Determination 2024/007

An authority's refusal to grant a building consent for construction of a new dwelling, and compliance of a proposed foundation design with Clause B1 *Structure*

16A Newark Close, Gate Pa, Tauranga

Figure 1: Construction detail of proposed anchor piles (not to scale)
(Note: dimensions are in millimetres)

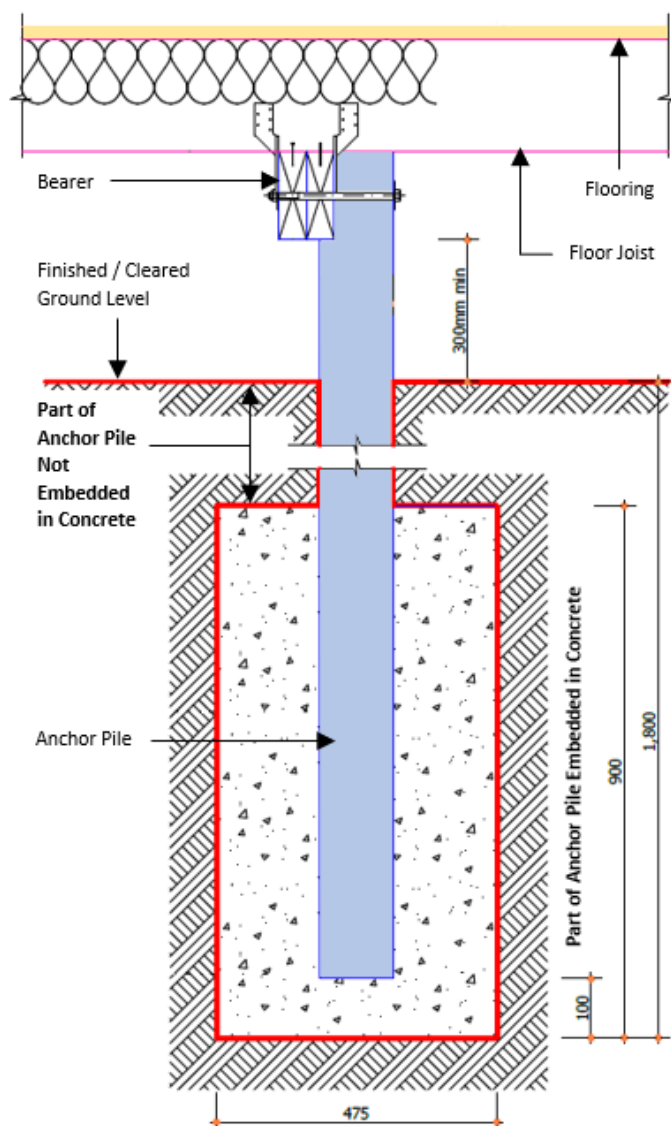
- 2.2.2. all the anchor and ordinary piles being installed to a depth of 1.8m below 'cleared ground level'⁶
 - 2.2.3. the lower half of the anchor piles being embedded in concrete (refer to Figure 1), with soil or similar fill material shown above (up to ground level).

4.33.2. The current design for the anchor piles where the lower half is to be embedded in concrete (refer to Figure 1), with soil or fill material shown above (up to finished ground level).

- 4.34. The geotechnical engineer has formed a view that the existing variable strength fill material is considered to provide the necessary lateral support for the anchor piles. However, they have not provided a specification for the soil or fill material that would need to be placed around the upper part of the pile (below cleared ground level, as shown in Figure 1) to fill the void in the bored hole above the concrete embedment.

- 4.35. In this case, it would only be the part of the anchor pile embedded in concrete that would be in direct contact with the existing variable strength fill material.

- 4.36. The designer has relied on demonstrating compliance with clause B1 using B1/AS1 and NZS 3604, however, there appears to be no provision in either document that allows for the concrete embedment to not be continuous below cleared ground level¹⁵.

- 4.38.1. The anchor piles do not conform to the concrete embedment requirements of NZS 3604 (specifically figure 6.10), nor does it have the minimum plan dimensions for the footings in accordance with paragraph 6.4.5.5, and table 6.1, of NZS 3604 above the embedded section of the pile (up to cleared ground level).

- 4.38.2. Paragraph 6.4.1.1(b)(iii)¹⁸ and figure 6.10 in NZS 3604 allows for a maximum height of an anchor pile above the embedment concrete (ie cleared ground level) to be 600mm to the highest connection for anchor piles. In this case detail D06 on plan sheet 14 of 30 indicates the proposed unembedded length (below cleared ground level) will be 900mm, and a total length of

approximately 1270mm from centre of the bolt connection with the bearer to the concrete embedment which exceeds the maximum permitted height.

- 4.38.3. The geotechnical engineer has not provided a minimum specification for the backfill around the anchor pile above the concrete embedment, that takes account of the smaller cross section of the unembedded timber.

- 4.38.4. No calculations have been provided showing the section of the anchor pile not embedded in concrete having the capacity to carry horizontal loads (from wind and earthquake actions) through the floor joists and bearers down to the embedded section of the pile.

- 4.42. Therefore, taking all the points above into account, I am of the view the current design for the proposed piled foundation for the dwelling (as detailed in the plans and specifications accompanying the application for building consent) does not demonstrate compliance with clause B1.

- 5.1.1. The authority did not adequately specify its reasons for refusing to grant a building consent for the proposed building work. I therefore reverse that decision.
- 5.1.2. The proposed timber pile foundation design does not comply with Building Code Clause B1 *Structure*.
